CITY OF LEE'S SUMMIT  
CODES ADMINISTRATION

Re: 1321 NE Country Lane  
Lot 6, Fritchie Bluff

Apex Engineers, Inc. observed the framing for the house located at the address above. Our firm was retained to address a structural issue noted during the rough-in inspection.

Job Address: 1321 NE County Lane Sheet # 1 of 3  
Summit

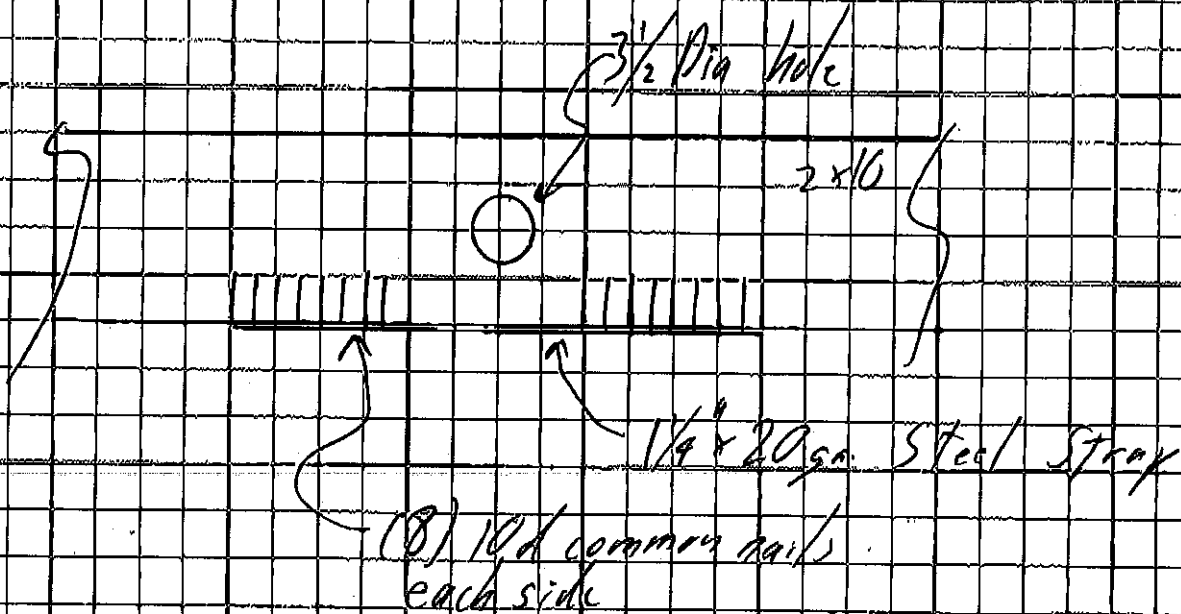
Several floor joists were bored with a larger diameter hole than allowed by code. The holes are 3-1/2" in diameter and are a minimum of 2" from the bottom of the joist. One of the joists was severed and headered off to the adjacent joists. After computations, our firm recommends the following:

- The floor joists on either side of the severed joist need to be doubled.
- Centered under each 3-1/2" diameter hole, fasten, to the bottom of the joist, a 1-1/4" wide, 36" long by 20 gauge steel strap (Simpson CS20) with a minimum of (8) 10d common nails on each side of the hole. See attached sketch for clarity.
